RE: Comments of the National Congress of American Indians (NCAI) on the Draft Supplemental Environmental Impact Statement for the Proposed Keystone XL Pipeline

**National Congress of American Indians
(NCAI) Comments** in response to the United States Department of State Draft Supplemental Environmental Impact Statement (DSEIS) For the **KEYSTONE XL PROJECT** Applicant for Presidential Permit: TransCanada Keystone Pipeline, LP released on March 1, 2013.

Figure 1 – Google Earth map depicting proposed Keystone XL Pipeline crossing through the state of Montana. Map indicates reservation and off-reservation tribal trust lands. Source: NCAI Analysis.

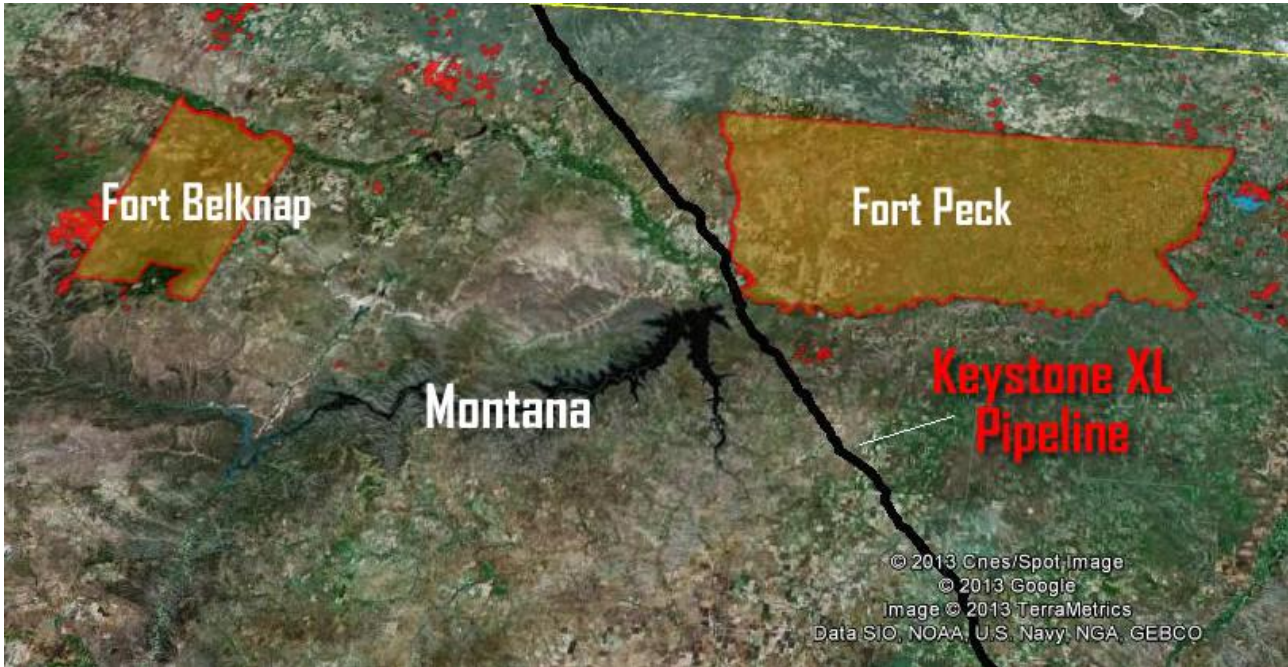
In Montana, the pipeline passes extremely close to and could have catastrophic impacts on the natural resources related to the Assiniboine and Sioux Tribes of the Fort Peck Indian Reservation. Additionally, there are off-reservation trust lands of the Turtle Mountain Band of Chippewa Indians near the pipeline in Northern Montana.

Figure 2 – Google Earth map depicting proposed Keystone XL Pipeline crossing through the state of South Dakota. Map indicates reservation and off-reservation tribal trust lands. Source: NCAI Analysis.

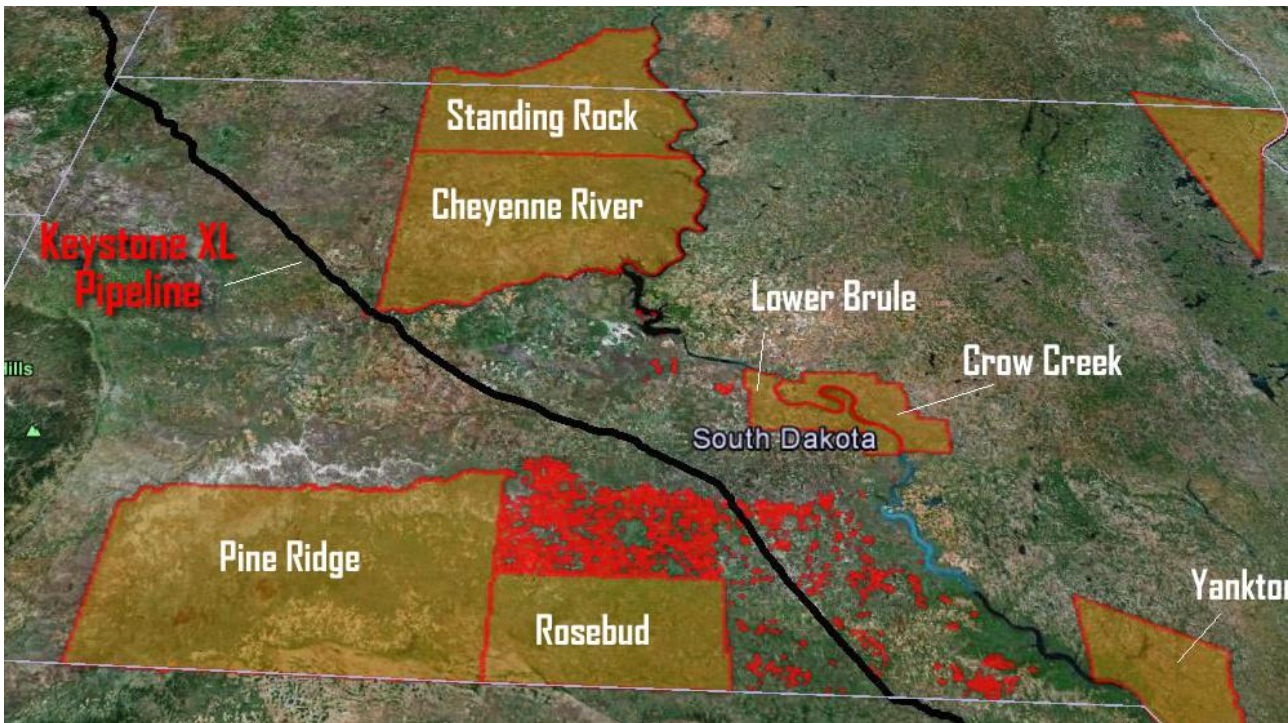
In South Dakota, the Project passes extremely close to and could have significant impacts on the natural resources related to the Cheyenne River Sioux Tribe of the Cheyenne River Reservation. The Project has the potential to have significant impacts on critical water supply services for the Oglala Sioux Tribe of the Pine Ridge Reservation, Rosebud Sioux Tribe of the Rosebud Indian Reservation, and Lower Brule Sioux Tribe of the Lower Brule Reservation. Finally, it is of significance to note that the Project navigates extremely close to off-reservation trust lands of the Rosebud Sioux Tribe of the Rosebud Indian Reservation.

Figure 4 – Google Earth map depicting proposed Keystone XL Pipeline crossing Cheyenne River at Milepost 430.07. Cheyenne River Indian Reservation is indicated. Source: NCAI Analysis.

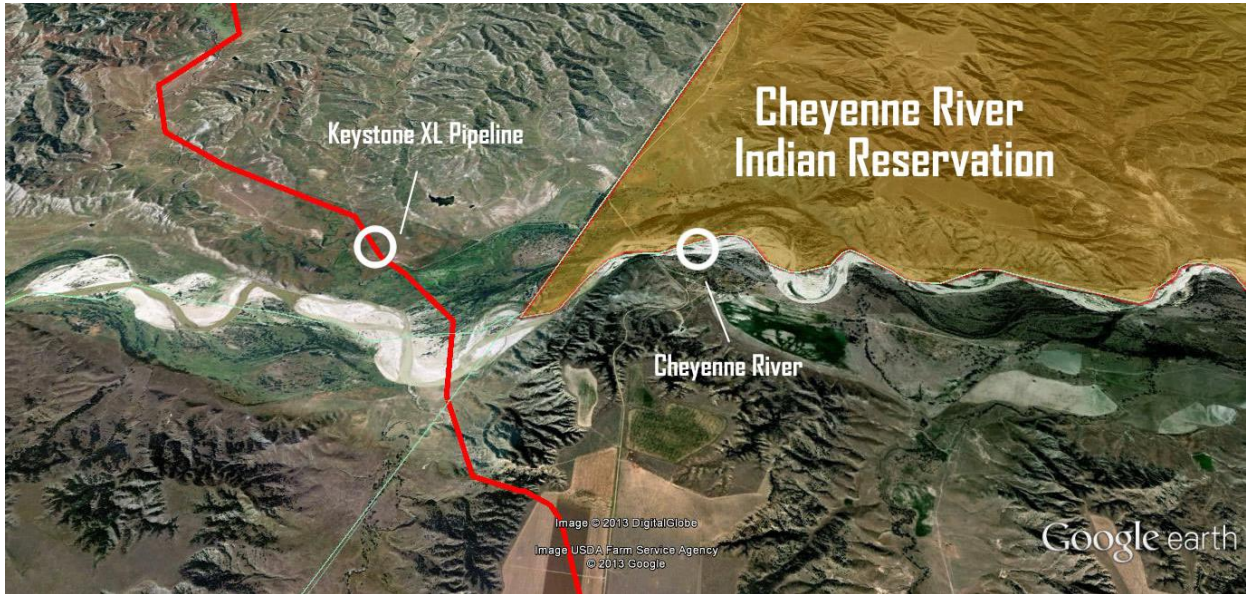
The Cheyenne River crossing of the pipeline occurs near the Southwestern most edge of the Cheyenne River Indian Reservation at milepost #430.07 and is approximately 1,600 feet wide. This river is a tributary of the Missouri River which flows easterly along the southern border of the Reservation to Lake Oahe, where both the Cheyenne River Indian Reservation and the Standing Rock Indian Reservation consist of the majority of the western shoreline of the Lake. Within the report there is no reference to any study of the potential environmental impacts to the surface water, ground water, fisheries, and water rights, or the cultural impacts of a spill to this tribal nation. It is the advice of NCAI to include this information in the final version of the SEIS. If further consultation is required the federal government should engage in this immediately as pursuant to Executive Order 13175.

Figure 5– Google Earth map depicting proposed Keystone XL Pipeline crossing through the general footprint of the Mni Wiconi Rural Water Supply Project in South Dakota. Reservation and off-reservation tribal trust lands are indicated. Source: NCAI Analysis.

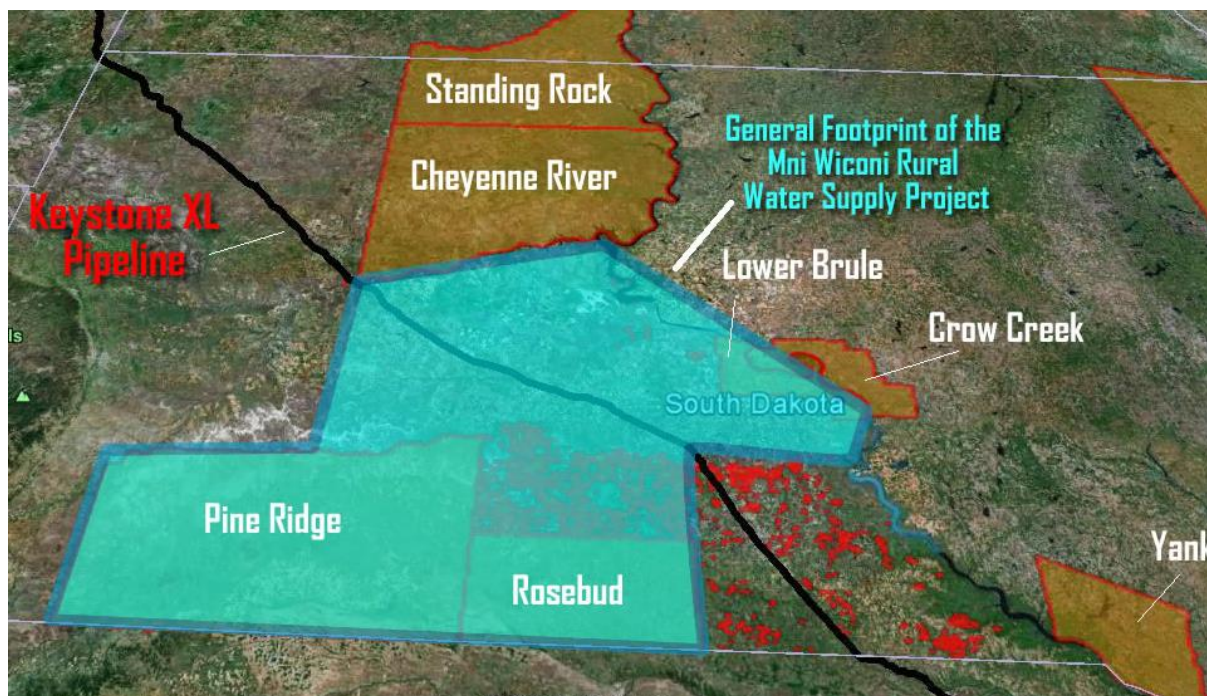
In section 3.3 (page 3.3 – 33), the DSEIS identifies that the Project would cross the MWRWSP distribution infrastructure – indicating that the BOR and tribal partners may have requirements for the crossings. While tribal nations, specifically the Oglala Sioux Tribe, have put forward concerns through official correspondence, beyond this reference the DSEIS fails to fully evaluate the risk posed by these crossings. It is our understanding that if the project is permitted, the tribe will insist that design requirements for crossings be developed cooperatively with BOR

The proposed pipeline would twice cross the MWRWSP. The Keystone XL pipeline will cross the MWRWSP at the Mni Wiconi Project Core Line - held in trust by the United States for the Oglala Sioux Tribe. The status of the land where the pipeline would cross the water line is problematic with the MWRWSP built through easements on private property that are held in trust for tribes by the BOR. The easement in Jones County allows the county to “cultivate, use, and occupy” the land as long as it does not endanger the MWRWSP water line.

There are two concerns raised by crossing water and oil pipelines: first, the pipeline could be damaged by corrosion and second, the water supply could be interrupted by a hot oil spill. The metal pipes could corrode more quickly due to their interaction with the soil and one of the crossings is near a section of the water line that includes PVC pipe that could be damaged by a hot oil spill.

The direct impact of pipe corrosion or damage from a spill would impact the Pine Ridge, Rosebud, and Lower Brule Indian Reservations who depend on, or will depend on (upon completion), the MWRWSP for their water. This is in addition to the tens of thousands of other non-Native South Dakota residents who could be affected. It is the advice of NCAI to include this information in the final version of the DSEIS. If further consultation is required the federal government should engage in this immediately as pursuant to Executive Order 13175.
